SUBMISSION TO BYRON VILLA WORLD

DA 10.2017.201.1 - 290 lot subdivision and concept plan for residual land, Ewingsdale Road Byron Bay

Dailan Pugh, BEACON, July 2017

Detail from Villa World showing part of acoustic wall, with 2.3m high Acoustic Wall above 2.1m Fill Batter. (note that the acoustic wall is actually identified as 2.6m at this location, and the fill as only 1-1.5m deep on the fill map, so it is hard to know what is actually being proposed)

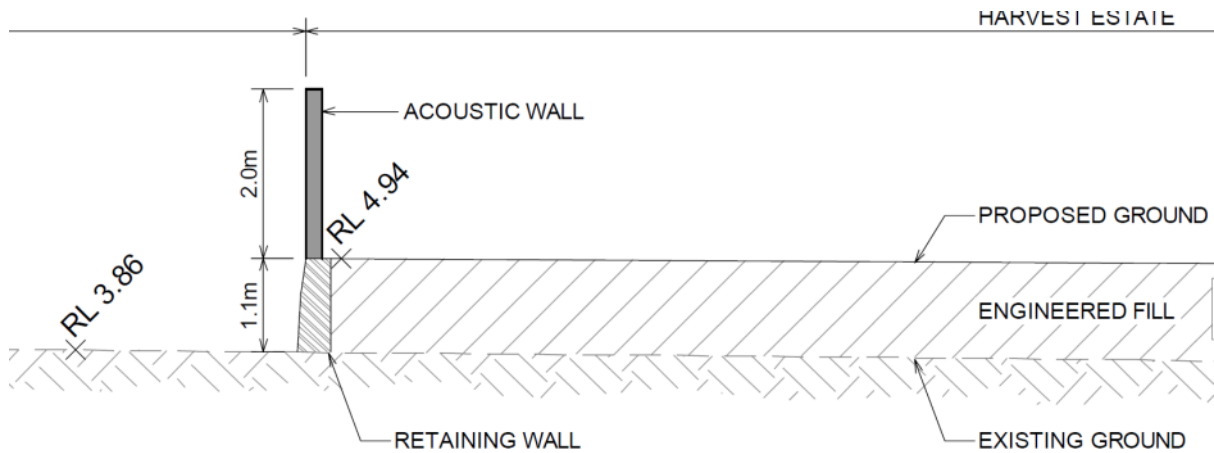
The entire frontage with Ewingsdale is to be filled with a depth of 0-2m of fill, mostly 1-2m. This means that if Scenario 1 is adopted the wall will be 2.3-4.6m tall fronting the road (with walls up to 6m tall not ruled out).

Example of proposed construction of Acoustic Wall on top of fill retaining wall. These structures maybe up to almost 5m tall along Ewingsdale Road, framing the entry into Byron Bay.

Council's map of the need to extend the road reserve onto West Byron, this includes that part of Villa World where the wall is to be the highest. There is obviously insufficient room for Council's proposed visual buffer on Council's land.

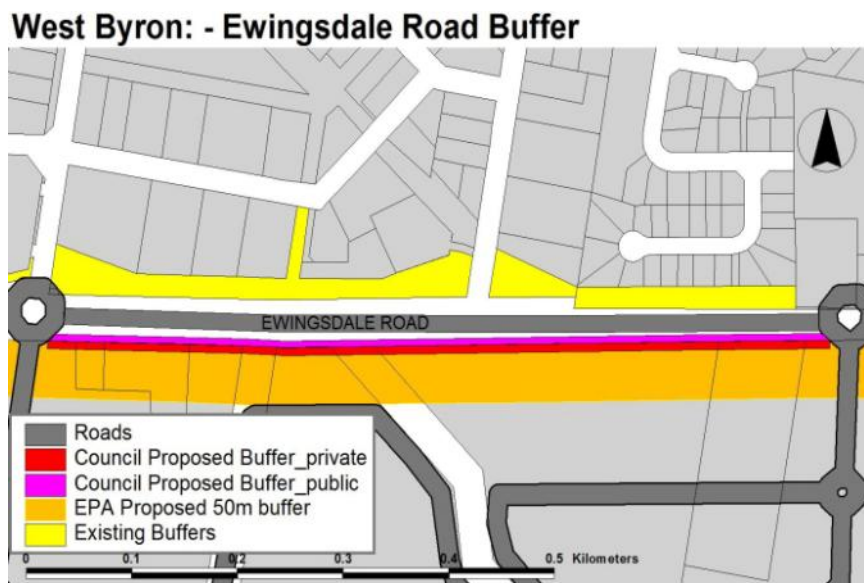
The Ewingsdale Road reserve must be fully retained as a public transport route, it is unacceptable that 6m of this vital artery is used as a visual buffer to a development. This is an irresponsible proposal that Council should be ashamed to promote. All of the development buffer, including the bicycle track, should be situated on the developer's land.

Even if the Council-Developer buffer was sought to be applied there is not the room for it. The Ewingsdale Road Reserve is 28-40m wide. The proposal is to turn Ewingsdale Road into 4 lanes, if the standard lane width of 3.5m is applied, with 2.5m shoulders, 3m wide swales and 2.5m bicycle tracks on each side, this represents 30m, without allowing for traffic separation or other infrastructure needs into the future. It is unreasonable and unacceptable for Council to propose using the public road reserve to buffer the development.

Probable Maximum Flood from BMT WBM (2010), based on sea-level rise of 0.9m and no increase in rainfall intensity.

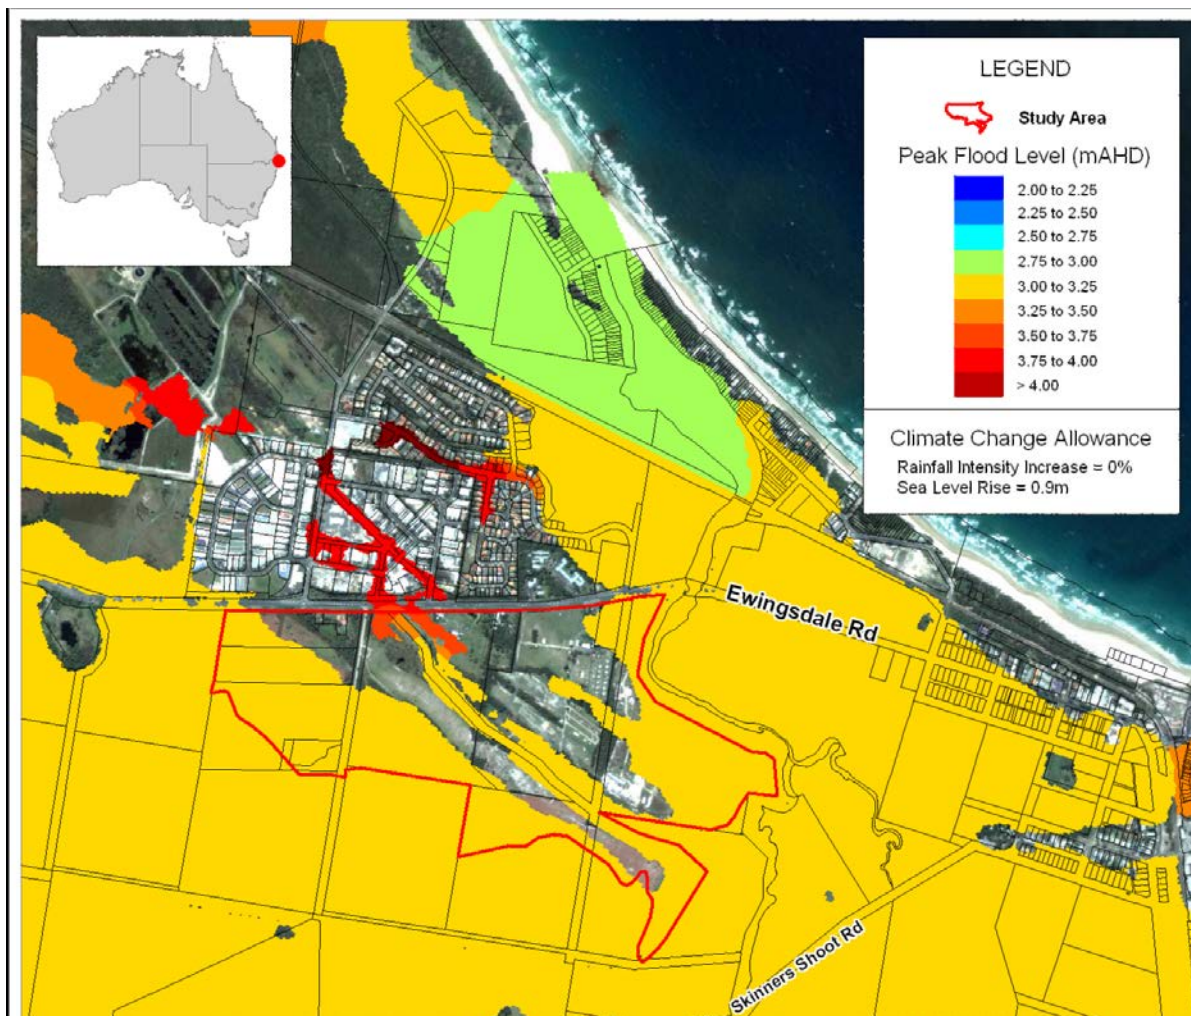
BSC's *Climate Change Strategic Planning Policy* (BSC, 2009) included guidelines on increases in rainfall intensity to be adopted for Flood Studies and Floodplain Management Plans of 10% and 30% for the 2050 and 2100 planning horizons. BMT WBM (2010) 100 year ARI design peak flood level is based "on a 10% increase in rainfall intensity, 0.90m sea level rise and a 0.5m freeboard allowance", with "no rainfall intensity increases ... accounted for during the PMF modelling".

With a freeboard allowance of only 0.5m there is no room for error when the risk of inundation is dependent on numerous conservative assumptions that are already proving to be under-estimated and under-stated.

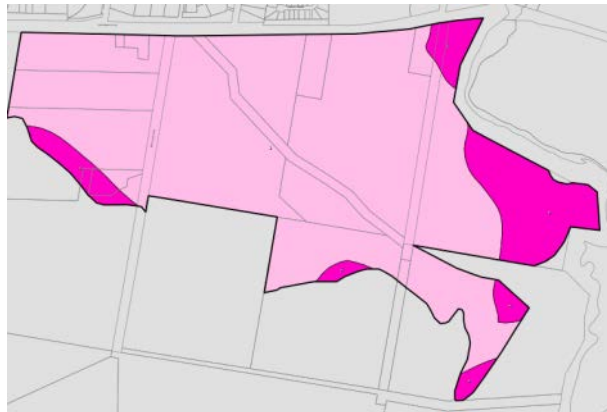
Most of the site will be subject to filling, which should avoid the need to excavate below 2m AHD, except for the swales and drains which will apparently entail extensive works below 2m AHD.

The proposal is predicated upon reconstructing the central drainage line into a huge drain up to 30m wide and 4m deep through the centre of the site to lower the water table and drain the surrounding soils into the Belongil estuary. As well as 77% of the site having Actual and Potential ASS, the

Mapping of Acid Sulfate Soils undertaken for the *Preliminary Acid Sulfate Soil Assessment* is excluded from Villa World's report, despite being totally different from the outdated map relied upon. The existing and proposed drainage system have been overlaid.

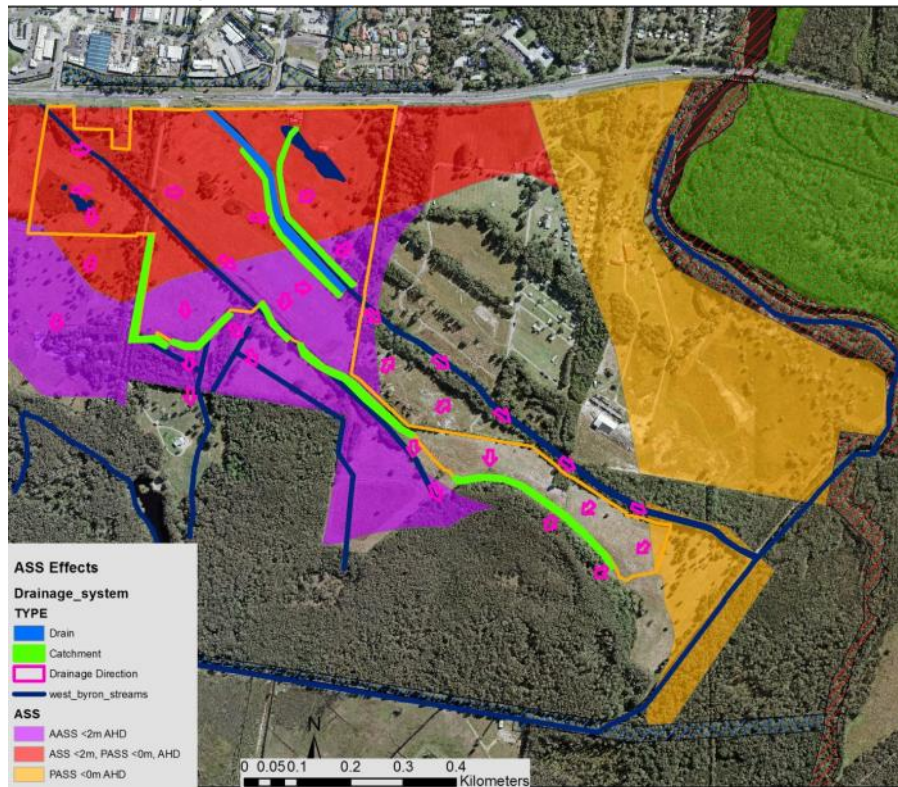
Different Mapping of ASS was prepared by the *Preliminary Acid Sulfate Soil Assessment*, though is not included in Villa World's reports.

Extract from fill plan showing excavation of swale to -1m and drain to -2m below current levels.

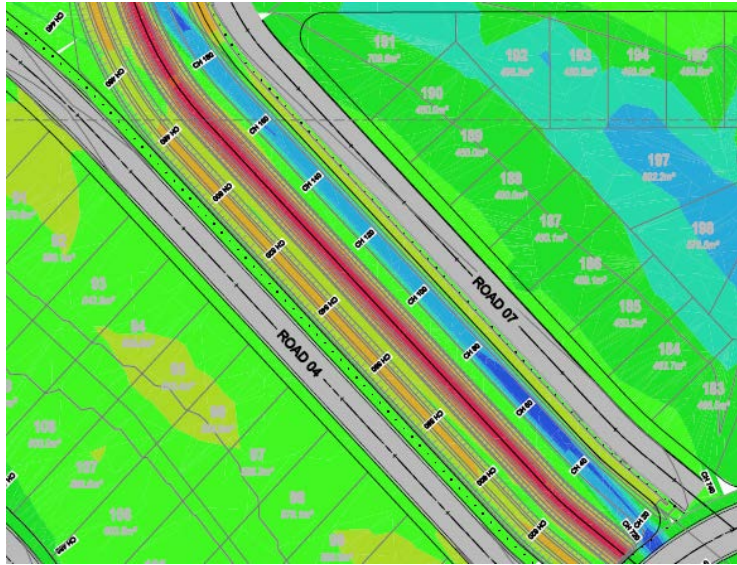
Sites BH7A, BH7B and BH6B were all located near the central drain and indicate significant acidity problems, that should warrant more detailed investigations.
